R. H. McCOMB ADDITION

Re: S/D97-93 -- One-Step Final Plat of R. H. McComb Addition

STAFF REPORT

CASE NUMBER: S/D 97-93 - R.H. MCCOMB ADDITION

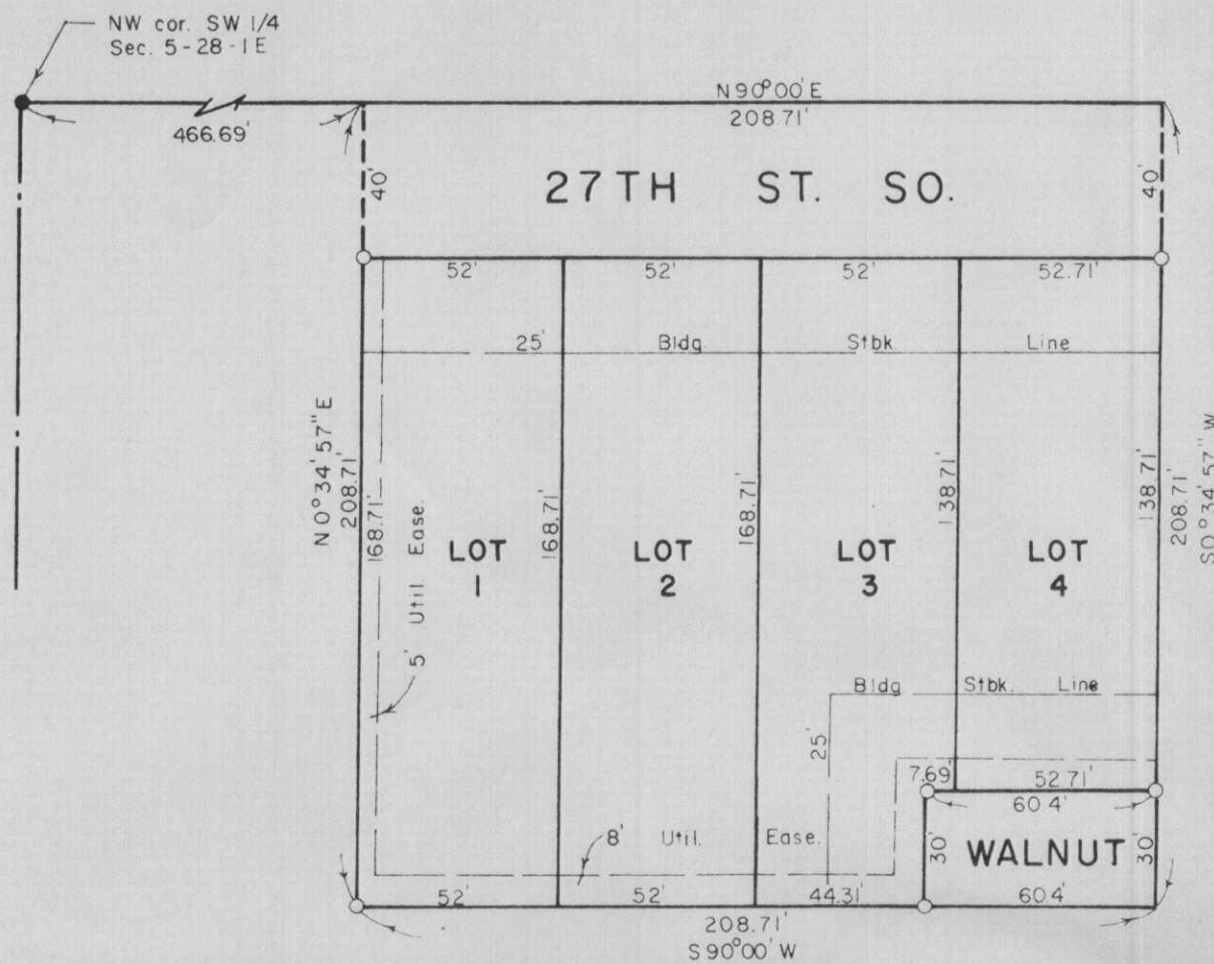
- C. The reference tie point to the section corner needs to be corrected to denote the range as "1E".
- D. This property is within a zone identified by the City Engineers' office as likely to have groundwater at some or all times within 10 feet of the ground surface elevation. Building with specially engineered foundations or with the lowest floor opening above groundwater is recommended, and owners seeking building permits on this property will be similarly advised. More detailed information on recorded groundwater elevations in the vicinity of this property is available in the City Engineers' office.

- G. The 15-foot setback platted from Walnut is insufficient. A 25-foot setback is required.
- H. On the final plat tracing, the Chair of the MAPC should read Richard Lopez.

- I. Since this plat is dedicating right-of-way for Walnut, the face of the plat shall clearly indicate such a dedication and appropriate language included in the plat's text. *A paving guarantee will be required for the T-type turnaround which will be held until Walnut is paved.*

- J. *Traffic Engineering and City Fire Department* needs to comment on the T-type turnaround proposed for Walnut Street which currently serves ten existing single-family dwellings south of this plat and measures 460 feet in length. *City Engineering indicates that the location of the T-type turnaround will probably necessitate a sanitary sewer easement for sewer service to Lot 4; and will meet with the applicant to discuss this issue. Traffic Engineering and Fire Department have indicated the acceptability of the turnaround.*
